Access Compliance Report

Public Rights-of-Way

(Curb Ramps)

Intersection ID: 7537	Main Street: BIRCHHOLLOW_DR	Cross Street: WILD_NURSERY_CT	Location:	E
ADA ID: CED3B5D7932E	Ramp Type: PerpDiag	Initial Pass/Fail: Fail	Overall Compliance: No	Severity Score: 21.25
Codes/Mitigation Info/Possible Solution		Field Measurements/Component Compliance

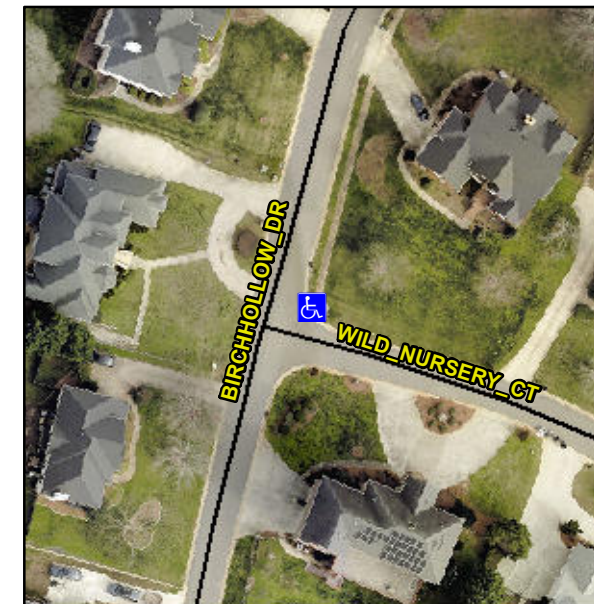
Not Found, R304.5.1, R304.2.2

Compliance	Description	Data	Compliance	Description	Data
N/A	Ramp Length (in)	46.0	No	Ramp Slope (%)	8.7
No	Ramp Width (in)	43.0	Yes	Ramp XSlope (%)	1.4
N/A	Flare Type LT	N/A	N/A	Flare Type RT	N/A
N/A	Flare Slope LT (%)	N/A	N/A	Flare Slope RT (%)	N/A
N/A	Flare Traversable LT?	N/A	N/A	Flare Traversable RT?	N/A
N/A	Landing Length (in)	N/A	N/A	DWS Provided?	N/A
N/A	Landing Width (in)	N/A	N/A	DWS Contrast?	N/A
N/A	Landing Slope (%)	N/A	N/A	DWS Length (in)	N/A
N/A	Landing X Slope (%)	N/A	N/A	DWS Full Width?	N/A
N/A	Landing Curb? (Y/N)	N/A	N/A	DWS Offset (in)	N/A
N/A	Shared Landing?	N/A			
N/A	Gutter Ponding?	N/A	N/A	Gutter Slope (%)	N/A
N/A	Gutter Lip Ht (in)	0.5	N/A	Gutter X Slope (%)	N/A
N/A	Painted X Walk1?	No	N/A	Painted X Walk2?	No
	X Walk 1 Direction	To W		X Walk 2 Direction	To S
N/A	X Walk 1 Width (in)	N/A	N/A	X Walk 2 Width (in)	N/A
	X Walk 1 Slope (%)	N/A		X Walk 2 Slope (%)	N/A
	X Walk 1 X Slope (%)	N/A		X Walk 2 X Slope (%)	N/A

N/A	Ramp inside XWalk1?	N/A	N/A	Ramp inside XWalk2?	N/A
	Road Slope (%)	2.3	N/A	Clear Space?	N/A
	Road X Slope (%)	6.6	N/A	Clear Space to XWalk (in)	N/A
N/A	Any Obstructions?	N/A	N/A	Storm Grate/Utility Hazard?	N/A
	Obstruction Type			Storm Grate/Utility Type	
		N/A			N/A
		Yes		Surface Condition? (G/P)	Good

Remove & Replace Curb Ramp With Two New Directional Ramps or Equivalent.
